**ADDENDUM NO. 2  
TO PLANS AND SPECIFICATIONS FOR THE  
ALPENA WATER PRODUCTION PLANT (WPP) CLEARWELL REPLACEMENT  
& INFRASTRUCTURE IMPROVEMENTS**

**ISSUED:** March 11, 2024

HRC Job No. 20220751

PUMP CONTROL PANEL MOUNTING RACK  
SUPPORTS (BY GENERAL CONTRACTOR)

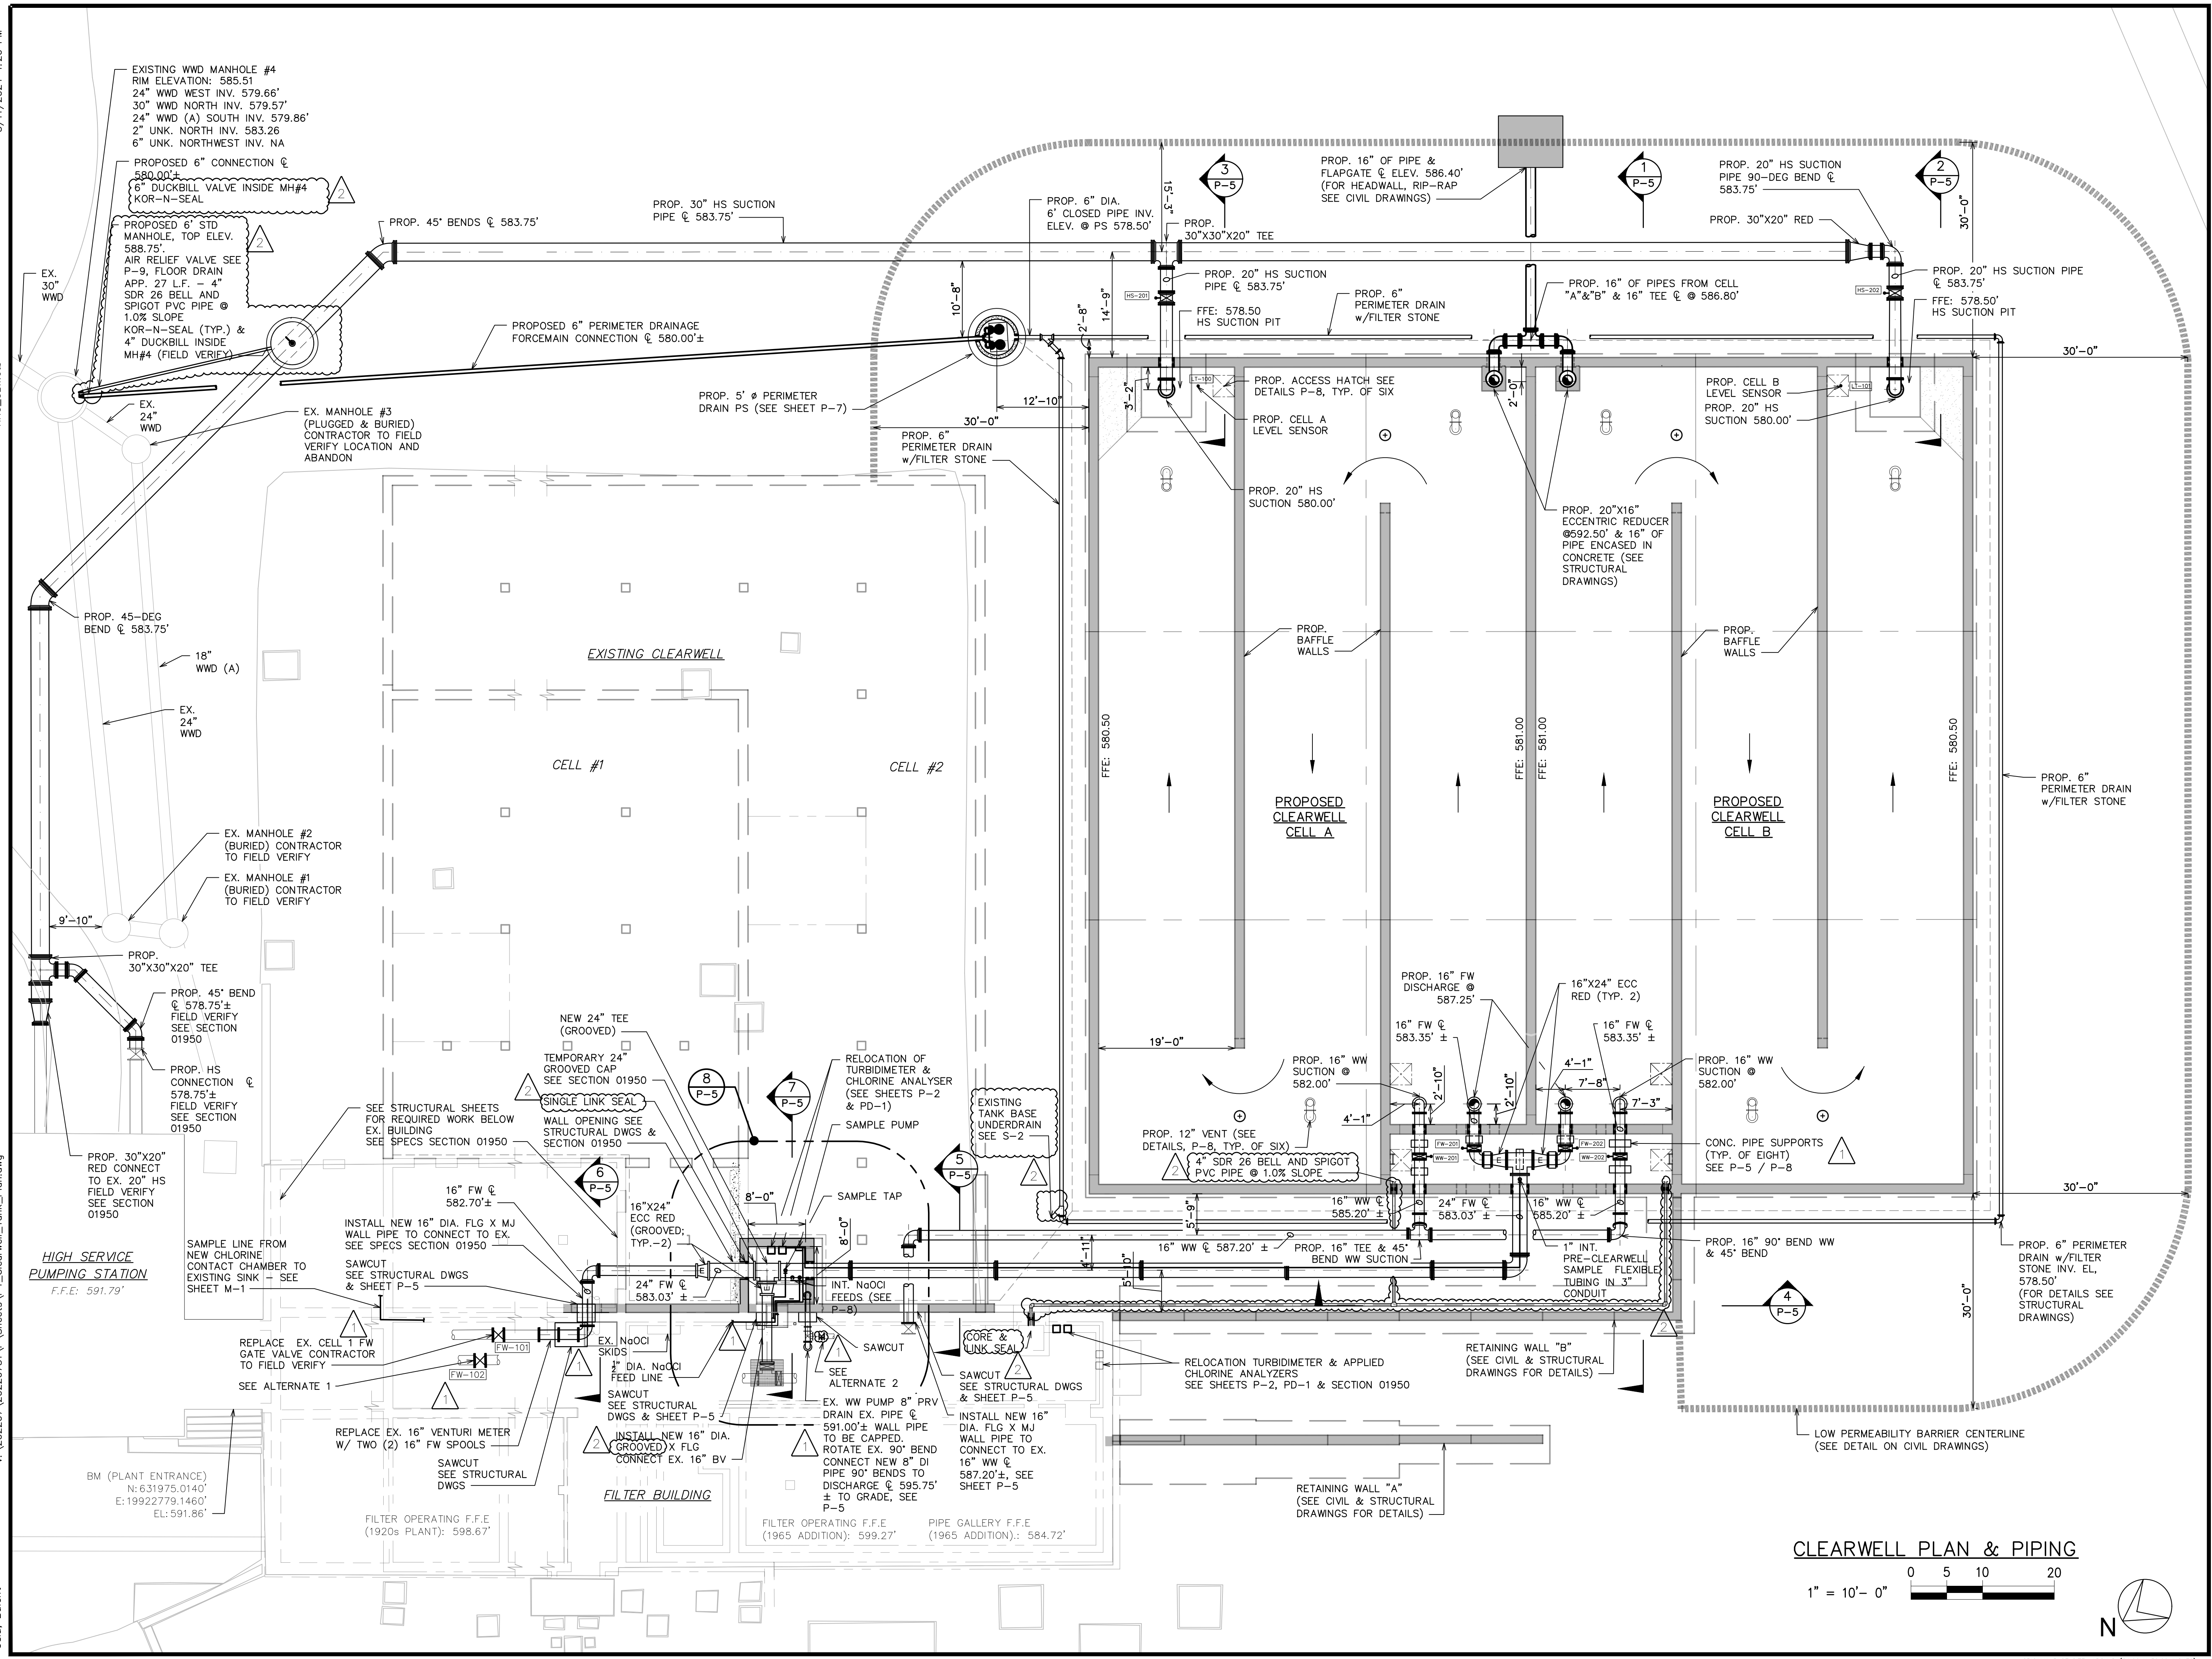
4. SHEET S-11 (Not Issued)
  - a. Wall Elevation 1 – Delete linework indicating grounding wire and Key Note 7 pointing to it.
  - b. Key Notes – Upper right corner of Sheet – Delete Key Note 7.
5. SHEET P-4 (Issued) – See updated sheet.
6. SHEET P-5 (Issued) – See updated sheet.
7. SHEET P-9 (Issued) - See updated sheet.
8. SHEET E-2 (Not Issued) – Add the attached sketch, “Pump Control Panel Mounting Rack Supports”, to Sheet E-2.

GENERAL CONTRACTOR TO PROVIDE THE RACK FRAME AND CONC. FOUNDATION FOR SUPPORTING THE PANEL THAT TEMPEST WILL PROVIDE. ELECTRICIAN TO PROVIDE GROUNDING FOR THE RACK.
